Item Name: Baggage Compartment Protector - Wall

Work Order ID: 159733

DART SERVICE INSTRUCTION

TO AMEND INSTALLATION INSTRUCTIONS IIN-D407-781-2 REV. A OR LATER APPROVED REVISION
AND INSTRUCTIONS FOR CONTINUED AIRWORTHINESS ICA-D407-781 REV. 3 OR LATER REVISION

**FIGURE 1 - D3879-1 BAGGAGE COMPARTMENT WALL
PROTECTOR - ALTERNATE INSTALLATION**

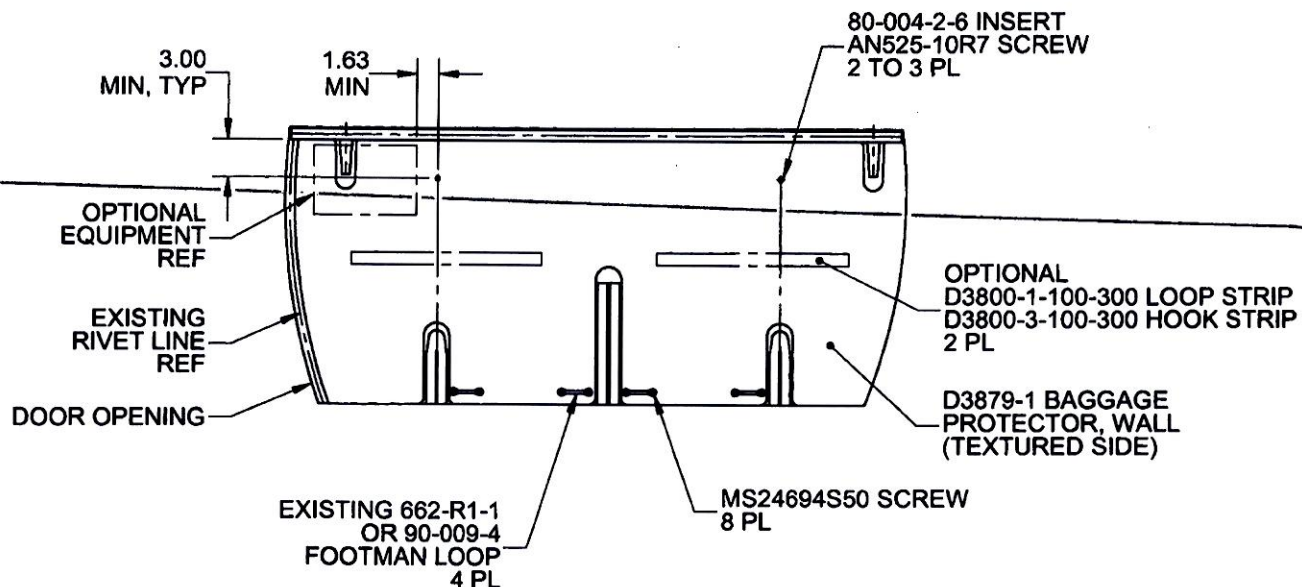
In some aircraft, the top portion of the D206-781-041 Baggage Compartment Wall Protector Kit cannot be installed as indicated in IIN-D407-781-2. The purpose of this DSI is to provide an alternate mounting method to fasten the top portion of the D206-781-041 Baggage Compartment Wall Protector Kit.

It is acceptable to replace qty(2) D3930-1 Clips with qty(2) 80-004-2-6 Inserts. Locate and mark location of the two attachment holes on the baggage compartment wall as shown in Figure 1 of this service instruction. Install 80-004-2-6 Inserts at the marked locations in accordance with Section 3-2-12 of BHT-206-SRM-1. It is acceptable to trim the wall protectors to accommodate optional equipment or transfer attachment holes to the wall protector and install the optional equipment on top of the wall protector with longer fasteners.

Amend the D206-781-041 Baggage Compartment Wall Protector Kit parts list as follows:

Qty -061	Qty -031	Qty -041	Part Number	Description
X			D206-781-061	BAGGAGE COMPARTMENT PROTECTOR KIT (FLOOR AND WALL)
1	X		D206-781-031	BAGGAGE COMPARTMENT FLOOR PROTECTOR KIT
1		X	D206-781-041	BAGGAGE COMPARTMENT WALL PROTECTOR KIT
		2	AN525-10R7	SCREW
		2	80-004-2-6	INSERT
